UNITED STATES PATENT AND TRADEMARK OFFICE

APPLICATION NO.	FILING DATE	FIRST NAMED INVENTOR	ATTORNEY DOCKET NO.	CONFIRMATION NO.
10/527,133	03/08/2005	Francesco Sias	4462-13	9432

Office Action Summary

DETAILED ACTION

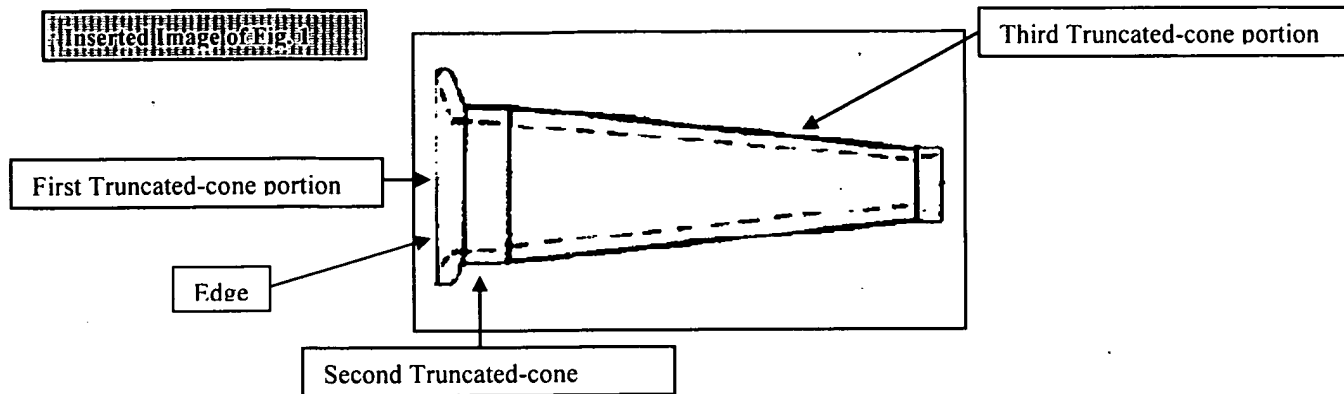
9. With respect to claims 25-28, Budding discloses an anoscope (fig. 1), comprising a first hollow body 4 (col. 2, lines 44-46) open at opposite ends (fig. 1) and a second hollow body 6

open at opposite ends (fig. 1) shapingly coupled with said first hollow body 4 and arranged coaxially inside said first hollow body 4.

13. With respect to claims 29-31, Budding in view of Kaji disclose the invention as discussed above. Budding further teaches the first hollow body comprises a first truncated-cone portion, wherein first truncated-cone portion is solidly connected with a second truncated-cone portion

that has a progressively decreasing cross-section, wherein the second truncated-cone portion is solidly connected with a third truncated-cone portion that has a progressively decreasing cross-section (see inserted image of fig. 1 below).

14. With respect to claim 32, Budding in view of Kaji disclose the invention as discussed above. Budding further teaches an edge (see inserted image of fig. 1 above) positioned in such a way that it faces the operator during use. It would have been obvious to one of ordinary skill in the art at the time of the invention to have used the first truncated-cone portion as the proximal end closest to the operator in order to load surgical instruments.
